Service Info

Tensioner arm 533 0075 30

Be sure to observe screw length

Photo: Right, old design / left, new design

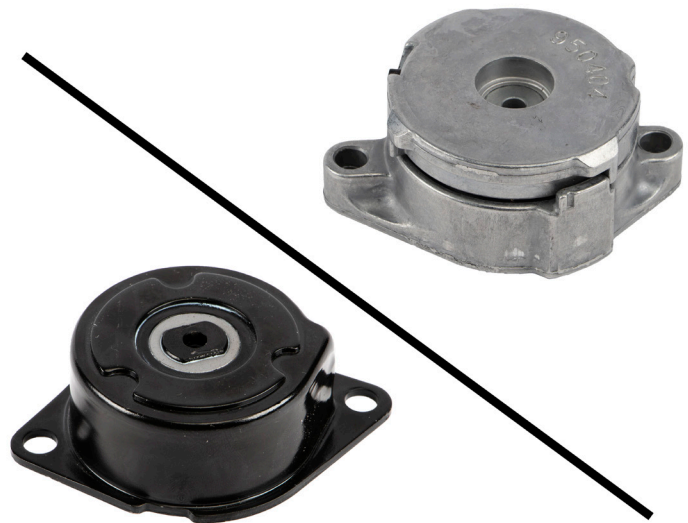
As part of the ongoing development of our products, tensioner arm 533 0075 30 has been modified. Proper installation of this new design requires shorter screws. The M8x35 screws have been replaced by M8x22 screws.

The Service Information bulletin shows the visual features of the previous design (pictured at right) and the new design (pictured at left).

For correct repair using the new tensioner arm 533 0075 30, only M8x22 size screws may be used!
